## 11 - BODY SHELL AND BODY JIG

*Front frame assembly - Frame upper cross member on 505's, all models*

From serial number : 505 . . . 1 471 225

A. 5162

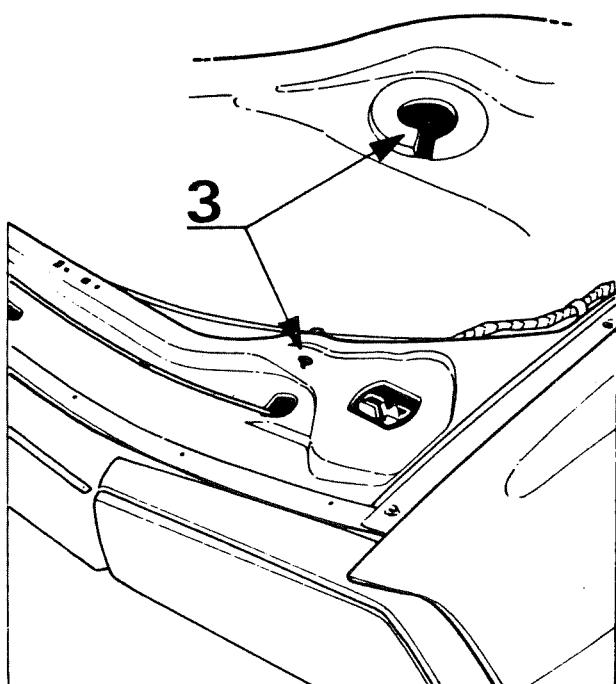
505 vehicles have been fitted with new headlamp load correctors (2).

Consequently, the front frame upper cross members have one hole, diameter 5mm (1) on each side, used to secure the new type headlamp load correctors (2), in place of the former 12 mm diameter spiral hole (3).

A. 5164

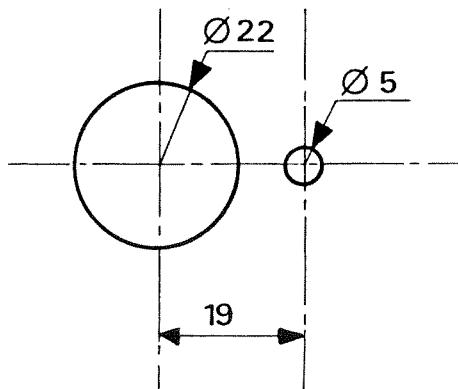
2 - *Fitting the early type in place of the later type*

- Flatten the spiral flange around the 12 mm diameter hole (3)
- Increase the diameter of the hole to 22 mm
- Drill a 5 mm diameter hole in the position shown to accommodate the load corrector retaining spigot.
